Wizards Workshop

TEKTRONIX INTERNAL USE ONLY

March 27, 1981
Issue 11-5

DM501A 200 Ω ZERO MODIFICATION

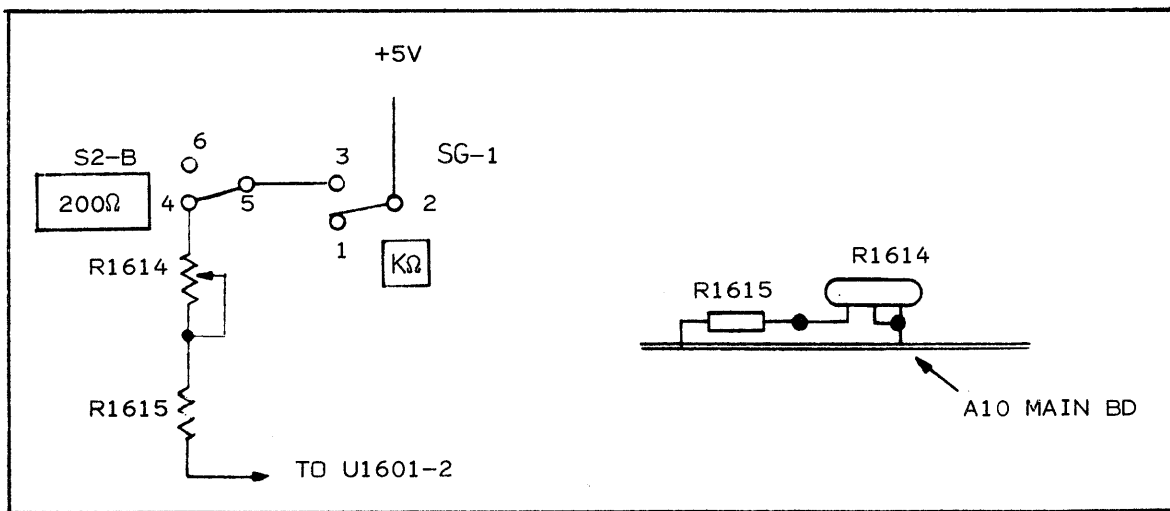
The following modification will help eliminate the problem of zeroing the 200 Ω range in the DM501A.

Change A10R1615 from Part Number 321-0382-00, 93.1K Ω to Part Number 315-0753-00, 75K Ω .

Add A10R1614, Part Number 311-1555-00, a 100K Ω Pot in series with A10R1615 (see attached figure).

On Page 4-11 of the adjustment procedure, add new step 2A:

2A. 200 Ω Zero Adjust (SN B025410 & up)

- a. Push DM501A k Ω function button in. Push 200 Ω range button in. Set; All other DM501A buttons out. Connect: Shorting bar across the DM501A LOW and VOLTS/ Ω INPUT jacks.
- b. Adjust: R1614 for a display of 00.00.
- c. Remove: Shorting bar from DM501A.

DIAGRAM 39 CENTER FREQUENCY CONTROL - Partial

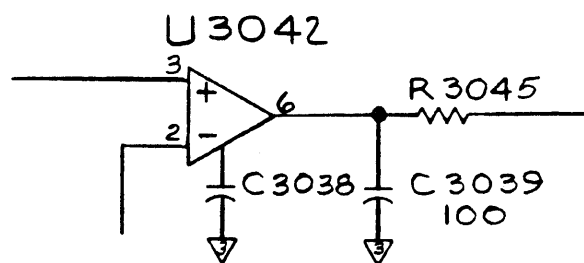
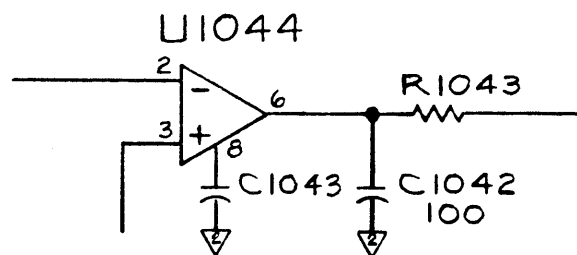
Reference: Corporate Mod #M41745
492/P Service Manual #2 P/N 070-2852-02
EFF SN B010760 (492)
EFF SN B011031 (492P)

ADD:

A46C1042	283-0330-00	CAP.,FXD,CER DI:100PF,5%,50V
A46C3039	283-0330-00	CAP.,FXD,CER DI:100PF,5%,50V

Fig. 4-9. Exploded drawing of fan assembly.

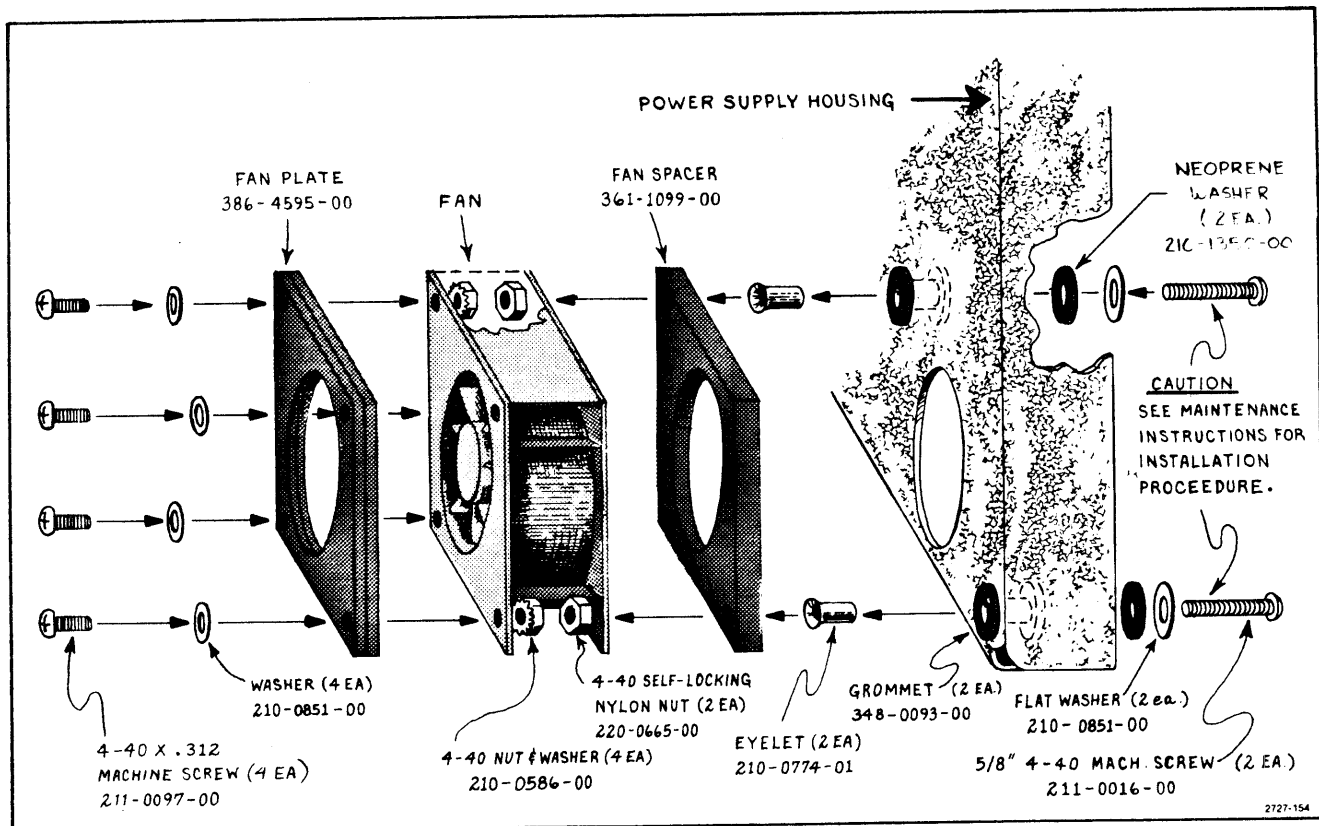
To help clarify the original article published in the February 20, 1981 issue of the Wizard's Workshop I have enclosed the procedure for "Compliant Mounted Fan Replacement". This procedure is now part of the Maintenance Section of the latest manual, P/N 070-2727-02, on pages 4-14 and 4-15. The manual was re-printed in December, 1980.

If the noted procedure is not followed and the fan mounting hardware is over-tightened, there is a good possibility that the instrument will experience 100HZ sidebands. This is due to the mechanical vibration caused by the fan on the RF deck.

Instruments SN B010322 and up may have a compliant mounted fan (see Fig. 4-9). It is important that the mounting screws for these fans are not over-tightened.

1. Refer to Fig. 4-9 and replace as follows:
 - a. Place the foam gasket between the fan housing and the power supply module cover.
 - b. Insert the two 5/8 inch machine screws, with washers mounted as shown in Fig. 4-9, through the two eyelets. Place the fan in position then while holding the nylon nut with needle-nose pliers, screw the mounting screws into the nut until the end of the screw is just flush with the nut. The nylon nuts are self locking.

FIGURE 1

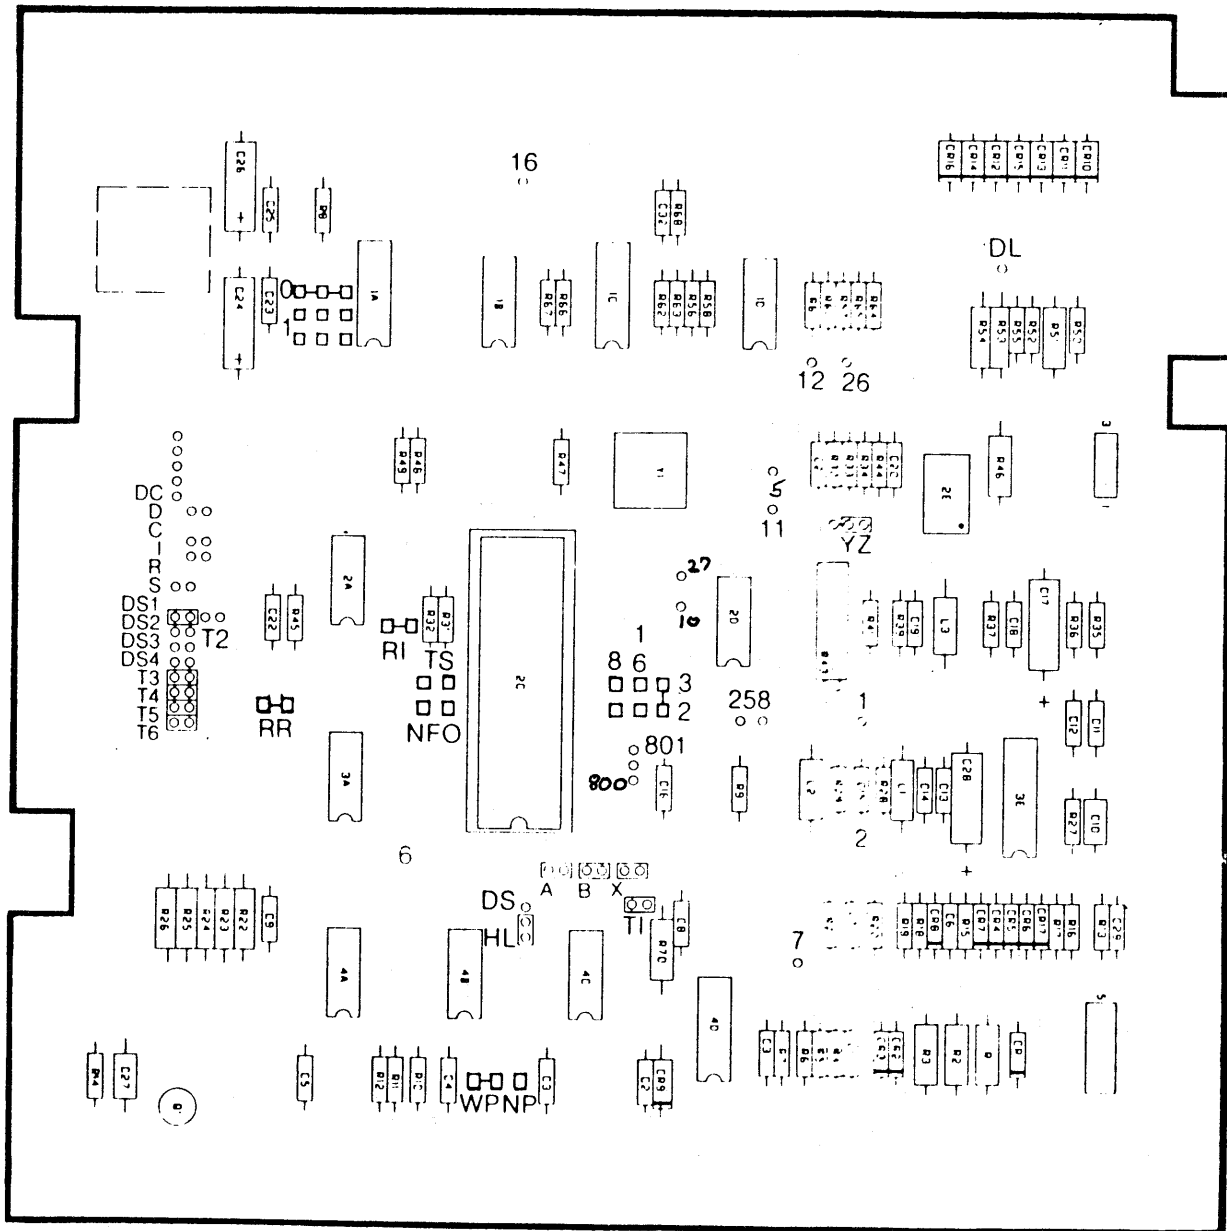
The Shugart Disk Drives are being shipped with a new circuit board using LSI components. The new board is electrically identical to the existing board and they are both interchangeable in the disk drive. Some of the strap options and test points are in different locations on the new board. Figure 1 is a diagram of the new board showing the locations of strap options and test points.

Figure 2 Location of strap L for "out" position.

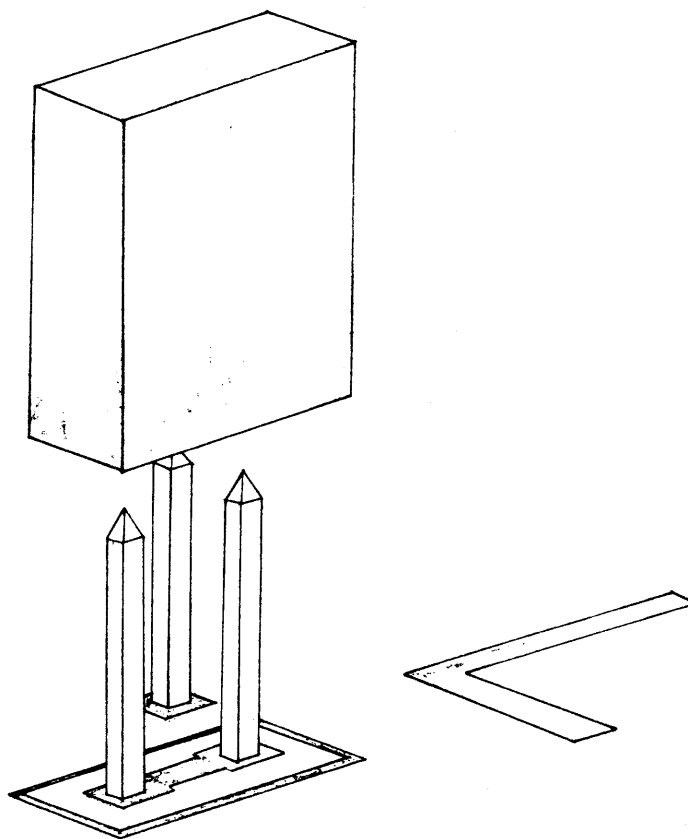
Table 1 gives the strap configuration of both old and new boards for 4907 operation. Note that the strap L option is not on the new board. On the old board a strap with a covered top should be used on the L pins to prevent them from shorting to the cabinet rails. The two pins that should be strapped are enclosed in a white square painted on the board. Do not connect the strap to the third pin which has the run connecting to C12 on the component side of the board. See figure 2.

Do not strap to the **IN** position on any instrument. Note: Trace between two strapped pins. A strap with a covered top should be used to prevent any possible shorting to the chassis.

Figure 7 & 8 are to help clarify the positions of the wire harness shown on figures 3, 4, 5, and 6. The new wire harness is to make the drive compatible to either the 4905 or 4907.

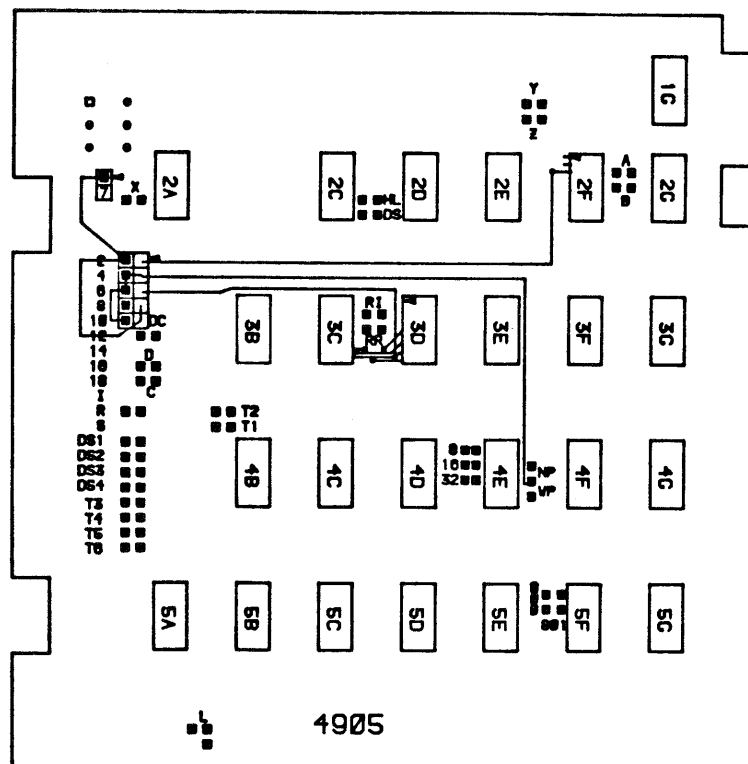
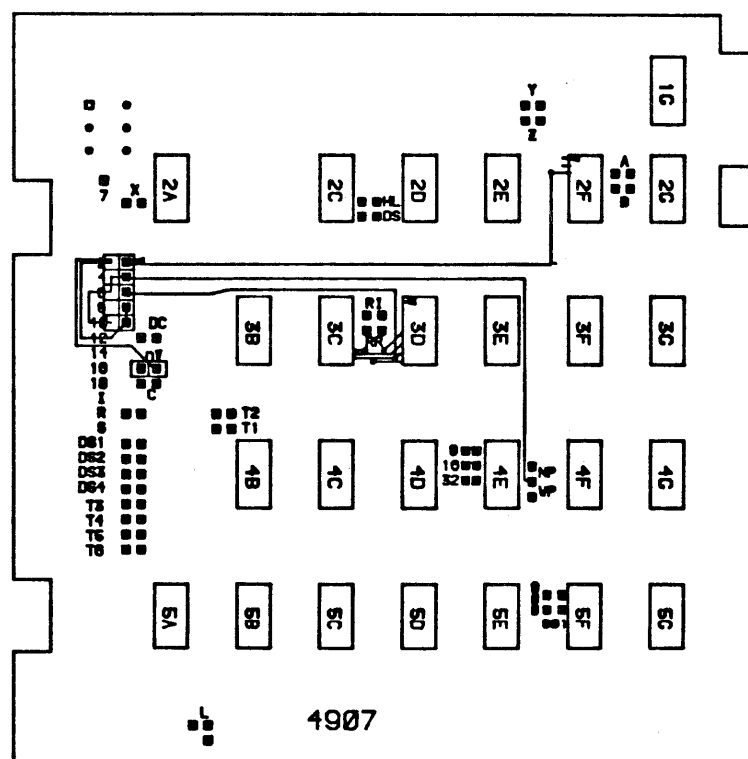
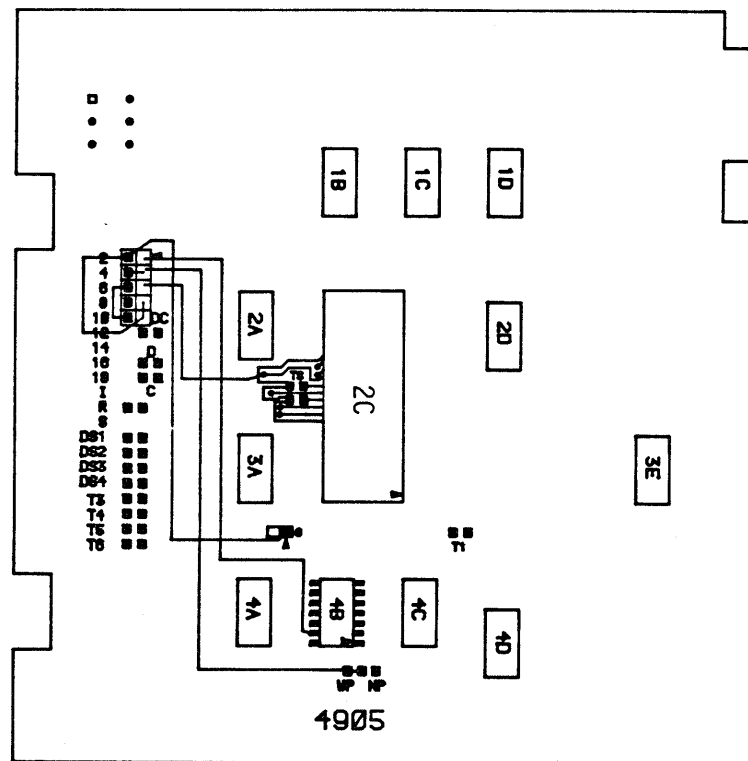
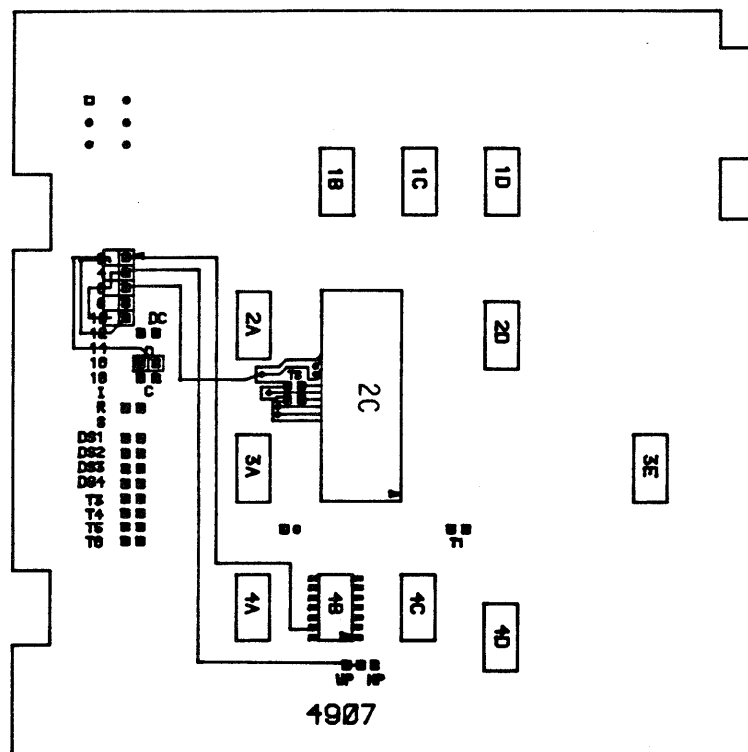
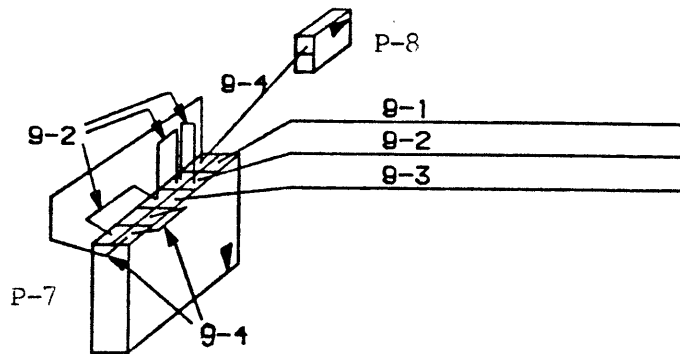
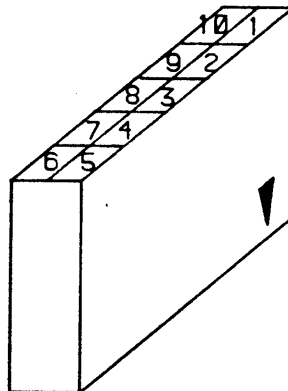
A new wire set has been put on both old and new boards, to make the drive compatible with present and future applications.
